# CONSERVATION COMMISSION AGENDA

Date: August 9, 2018  
Time: 7:00 pm  
Place: City Hall, Room 204

### I. WETLANDS DECISIONS

Za 33 WAYNE

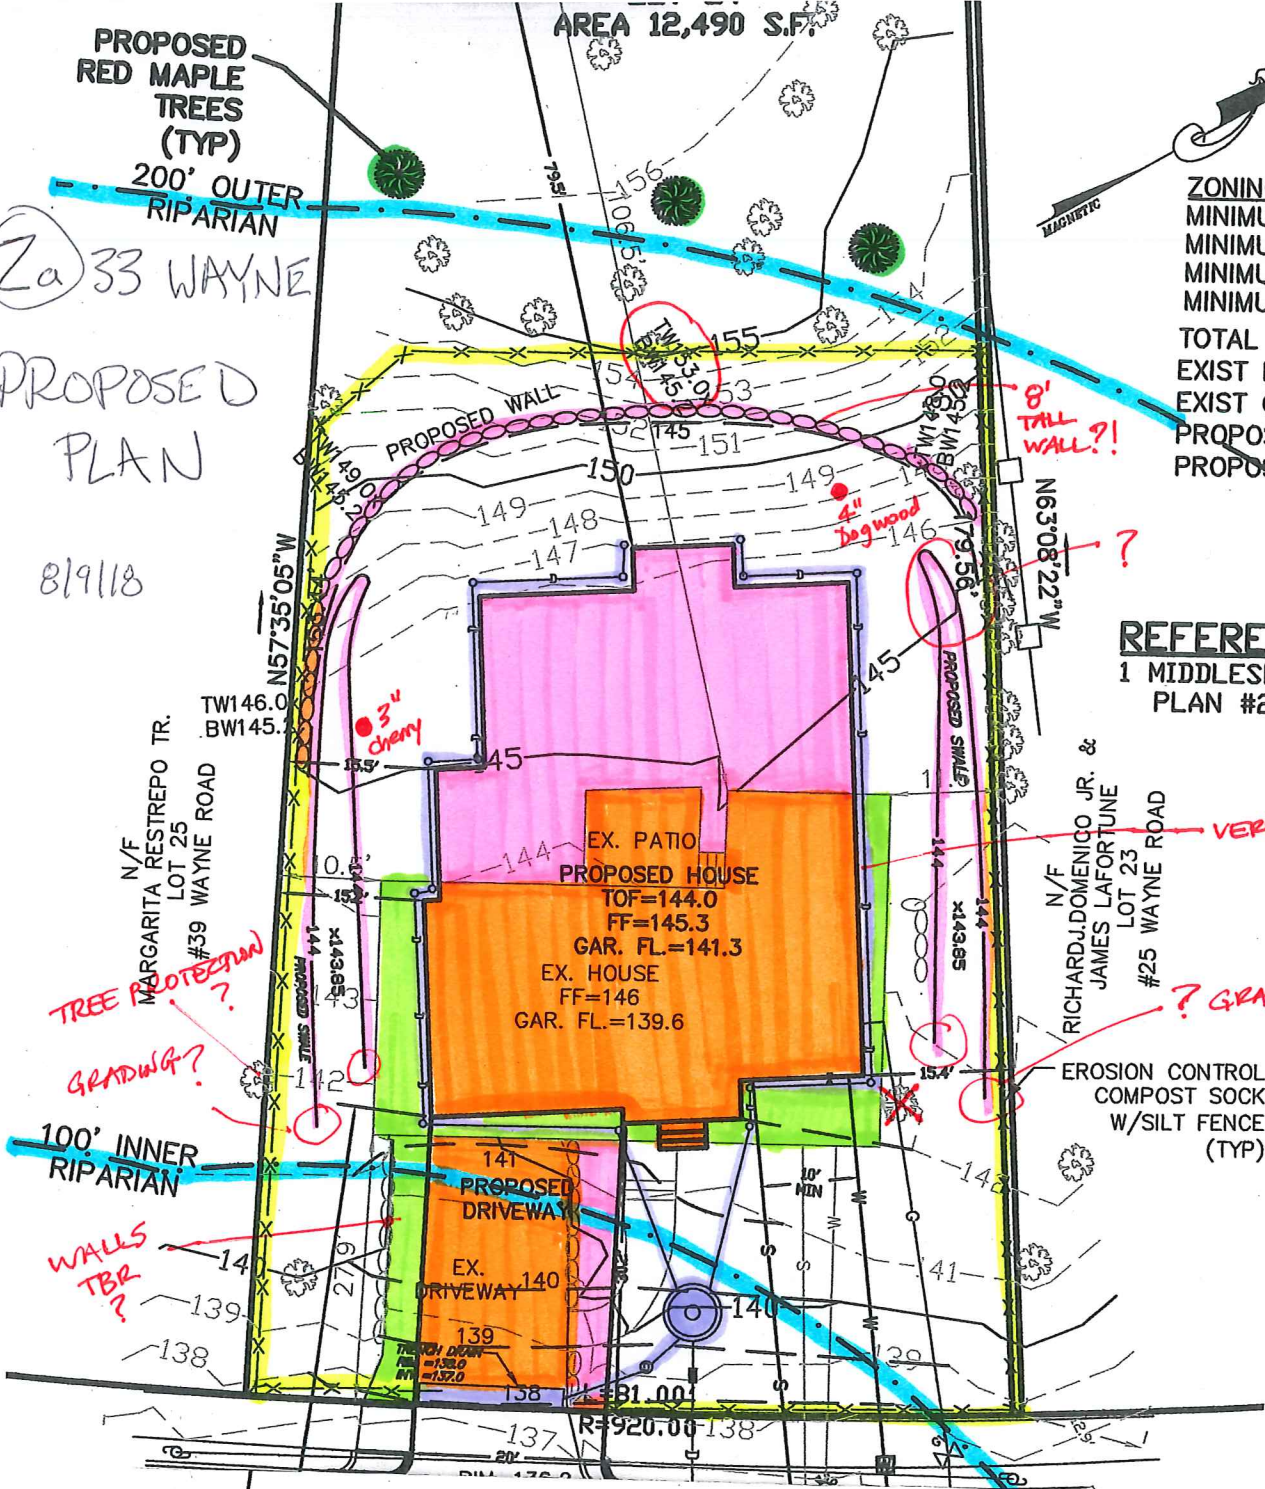
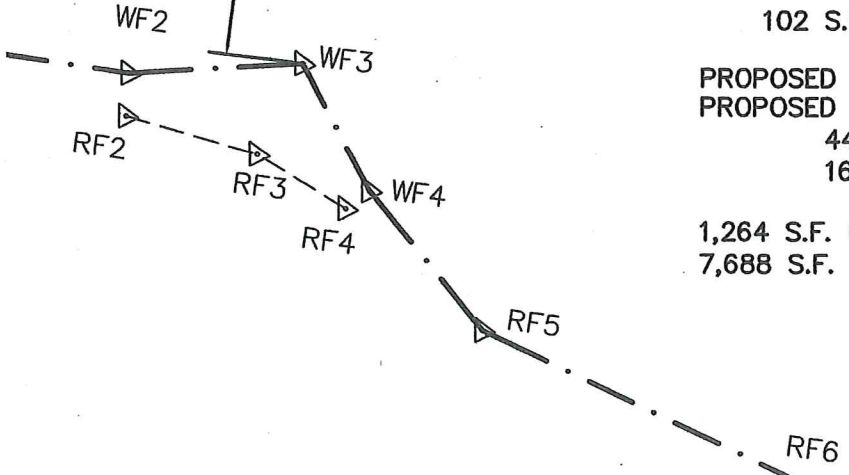
- The applicant is proposing to plant 3 red maple saplings; , outside the 200' RFA.
  - **Questions/Concerns**
    - Proposed project does not appear to meet all of the WPA performance standards, as purported in their application. Below are the 10.58(5) standards summarized with staff comments in italics following.

- (a) work shall result in an improvement – *There is an increase in impervious surface are in the RFA with no proposed mitigation in the RFA.*
      - (b) Stormwater management is provided according to standards – *WPA standards do not apply to single family homes; however, the capacity/detail for the drywell needs to be provided to determine if it meets City standards.*

- (c) Work shall not be located closer to the river than existing conditions – *Proposal meets this standard.*
      - (d) Proposed work ... shall be located ... away from the river except in accordance with 10.58(5)(f) or (g). – *Proposal meets this standard.*

- (e) The area of proposed work shall not exceed the amount of degraded area except in accordance with 10.58(5)(f) or (g). – *The proposed work will increase the amount of degraded area by 827 s.f.*

- (f) .... if restoration of at least 1:1 – *No restoration is proposed.*
      - (g) .... if mitigation of at least 2:1 – *The 3 proposed saplings are not sufficient mitigation for 827 s.f. of alteration and are placed outside the RFA.*

- (h) The issuing authority shall include a continuing condition prohibiting further alteration within the restoration or mitigation area, except as may be required to maintain the area in its restored or mitigated condition. – *The proposed plantings are not protected in any way for perpetuity. Any proposed mitigation needs to be within a bounded planting area to prevent mitigation plantings from being removed/alterd in the future.*

- The proposed grading changes for the drainage swales do not match up to existing grading lines.
    - The retaining wall is shown as being 8' tall.

- Driveway grading is unclear.
    - Proper protection for the neighbors' tree roots will be necessary.
    - The proposed location of the new home does not work with the existing site grading. Will there be a retaining wall or any cut/fill to support the back of the house?

- The roof runoff is to travel all the way around the house in gutters before entering a drywell in the front yard. Conservation staff feel this is not practical.

- Staff are concerned that the proposed drywell is too small to be taking all of the roof runoff and driveway runoff. Should another system be added?

- No trees on the plan are marked with protection, though the narrative states that no trees are to be removed. The tree closest to the front, right corner of the house will not survive demolition and construction as it is within 5' of the existing foundation.

- The proposed mitigation plantings should be moved within the jurisdictional area and should be an appropriate species for the upland soils of the site.

- Engineering has not commented on the project proposal yet, so further concerns may be noted.
  - Staff Recommendations: Await revised narrative and plans.

# 3a 53 BRANDEIS - PROPOSED PLAN

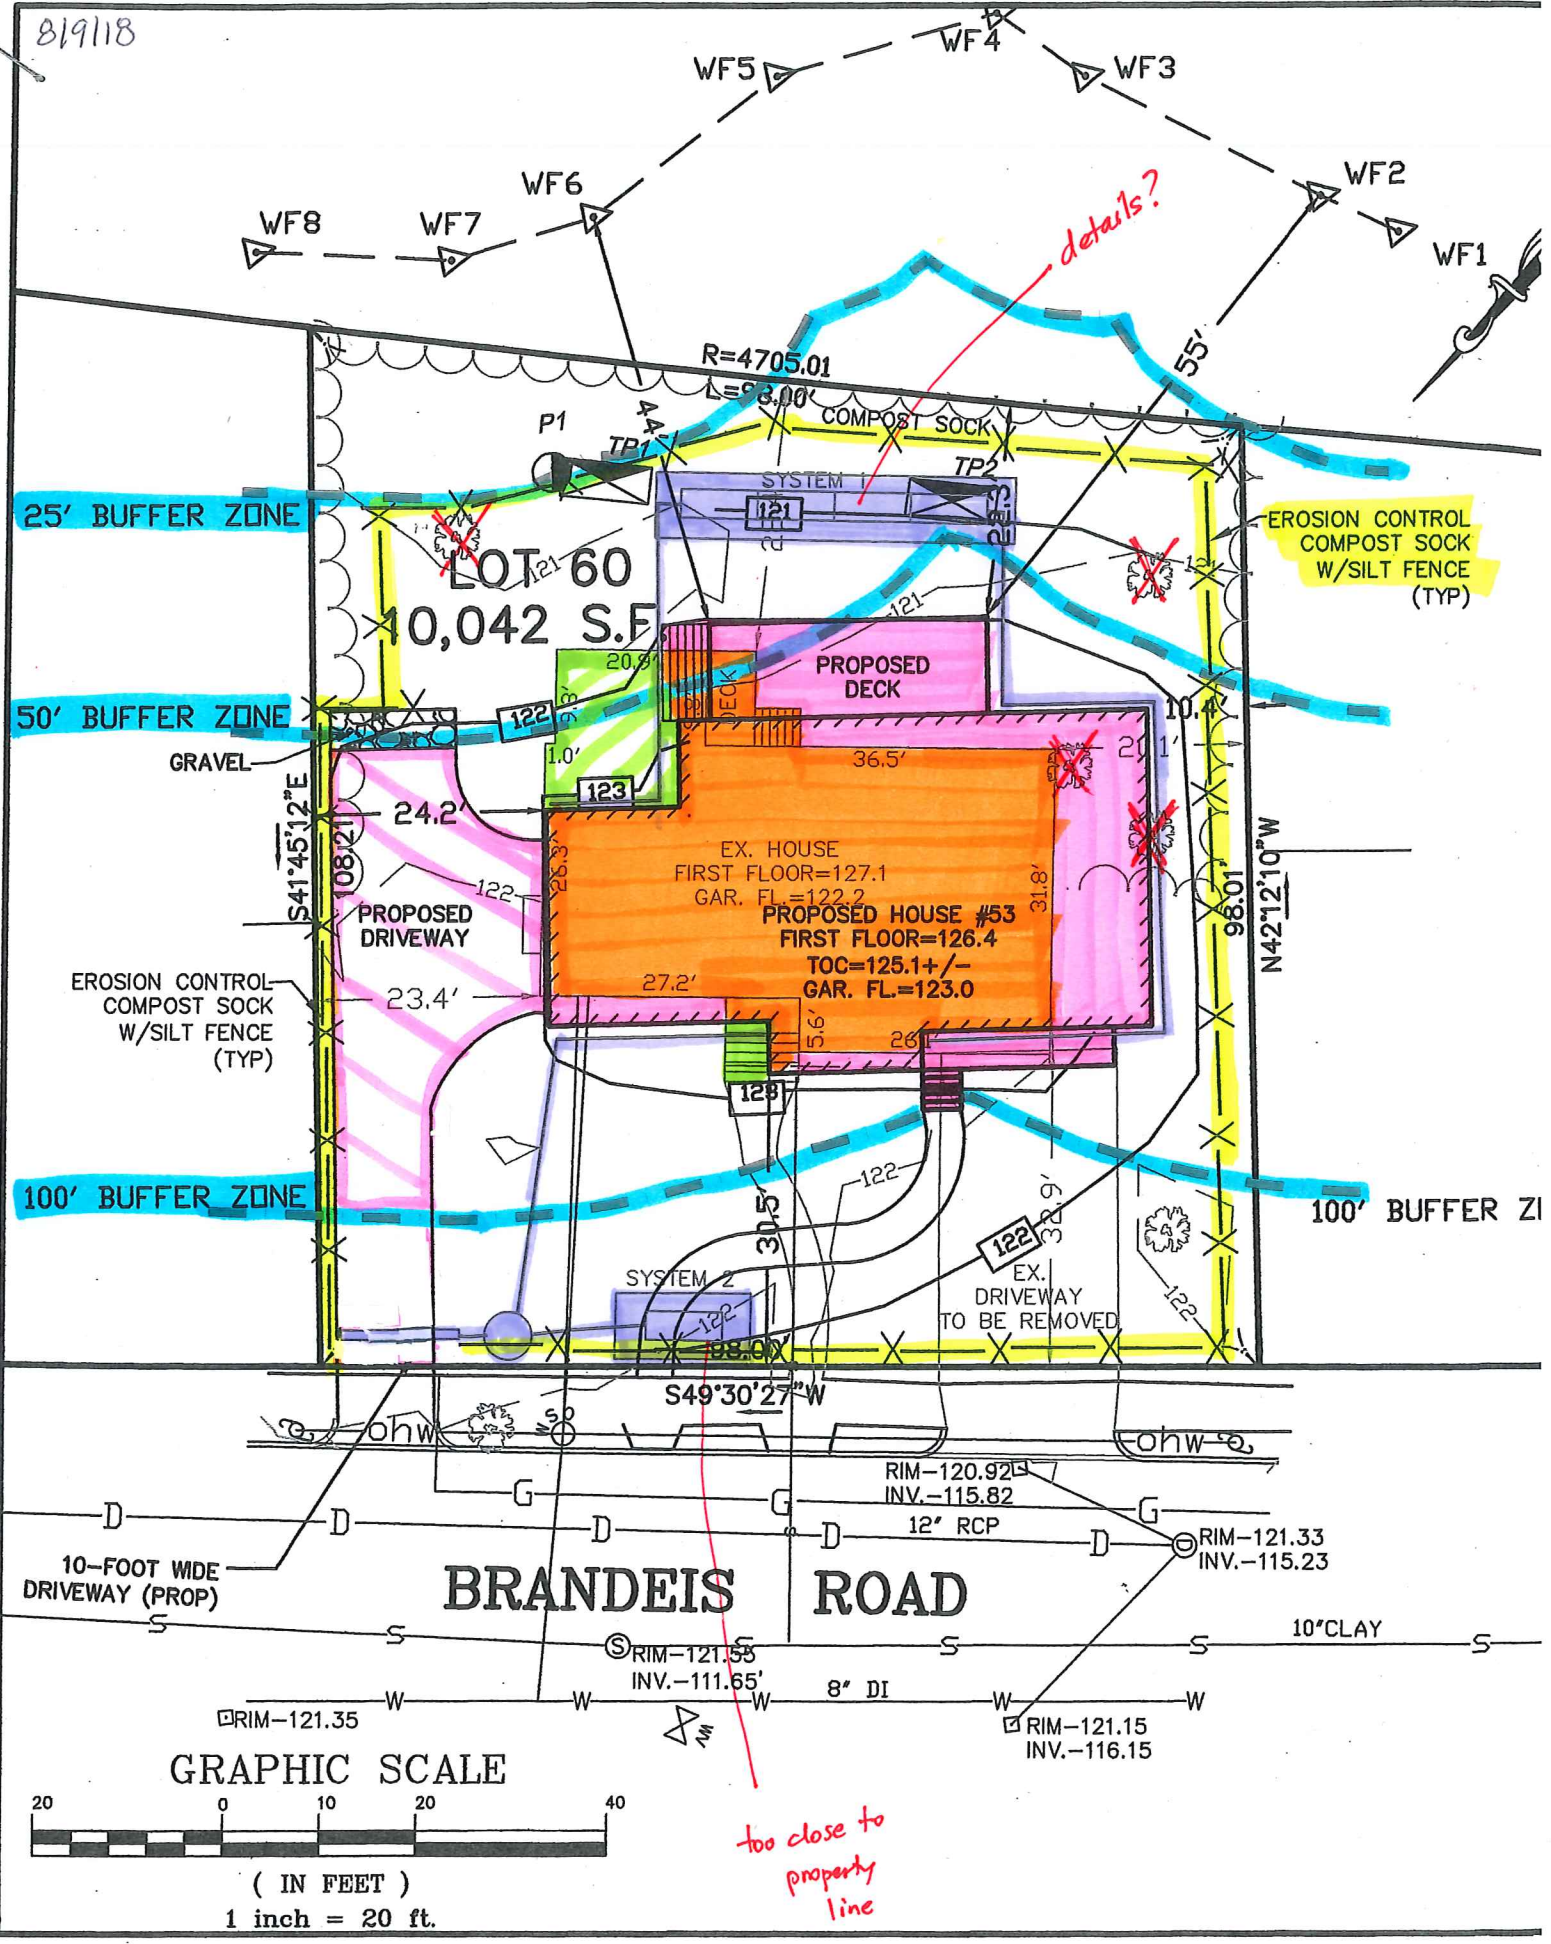
- Existing driveway shown as to be removed
    - Trees to be removed are now labelled
  - No details have been provided about the proposed infiltration systems (as requested in Engineering’s June 19 email that was forwarded to the applicant team: “The narrative indicates that the new impervious surfaces will be collected and infiltrated, the site plan shows two test pits and a perc test but no info submitted for the evaluation of the drainage design, additionally he shows a trench drain for the driveway & DMH to an infiltration system that is too close to the street must be a min. of 10’ off property line finally no grades, rim or invert elevations are shown for the proposed systems, and no details.”

- The front infiltration system still does not meet Engineering’s placement requirements (as noted in Engineering’s June 19 email – see above).
- Staff Recommendation: Await revised narrative and plans.

*details?*

*too close to property line*

# 4 MALVERN TER - PROPOSED PLAN

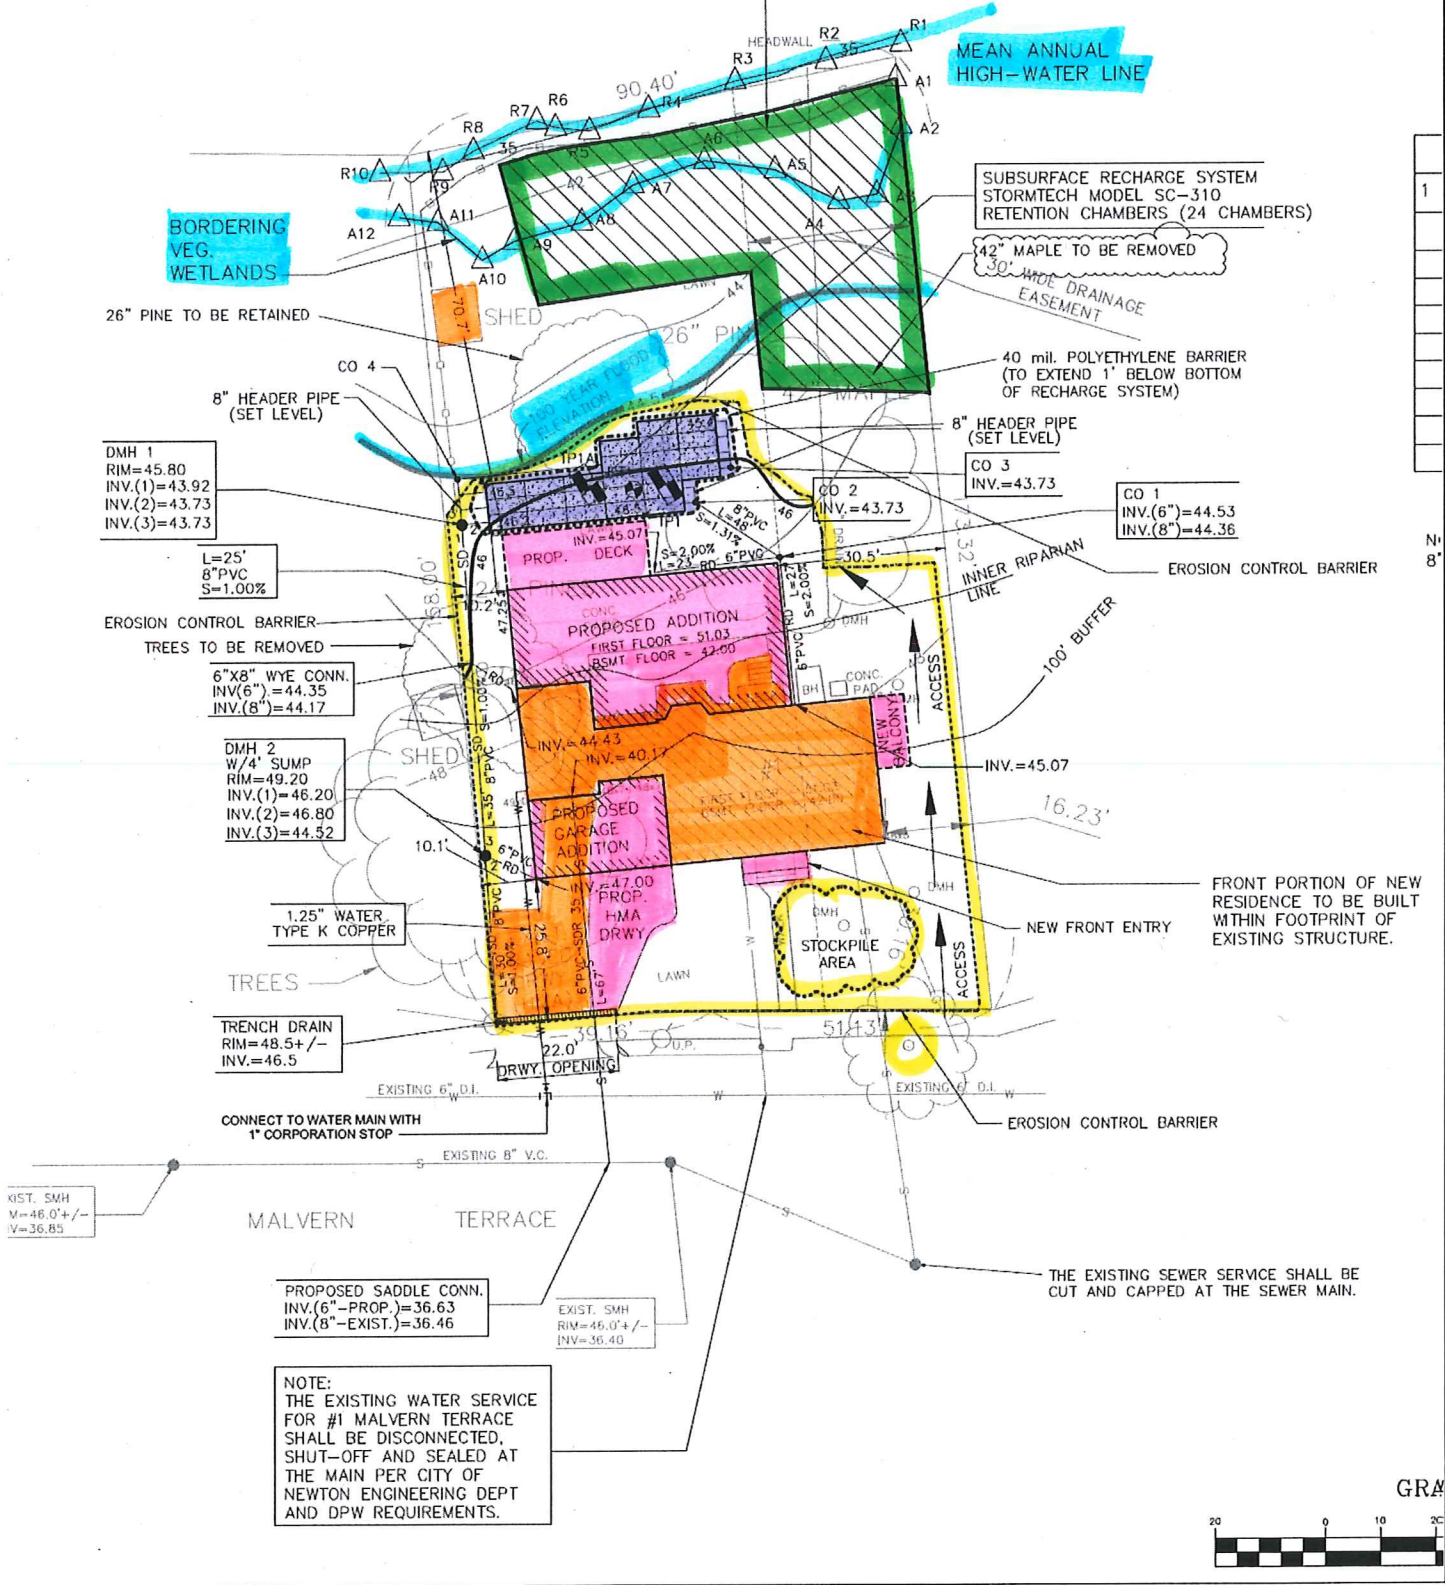
- **Plans:** No revised plans have been received at the time this agenda was submitted. Revisions requested were:
  - The O&M plan needs to be corrected from “inspected on a bi-annual (once every two year)” to “inspected on a bi-annual (twice every year)” and add “sweeping of the driveway on a regular basis to keep silt and debris out of the trench drain and system.”

- There is a slight error of the subsurface recharge system calcs. The storage range is exceeded by 0.02 feet (very minor), but engineer should add more stone beneath the system to offset the exceedance (with more stone there will be more storage volume).

- The O&M plan must be record at the registry of deeds to inform future homeowners about the required maintenance. Proof of recording must be submitted to the Conservation Commission.

○ Staff Recommendation: Await revised plans.
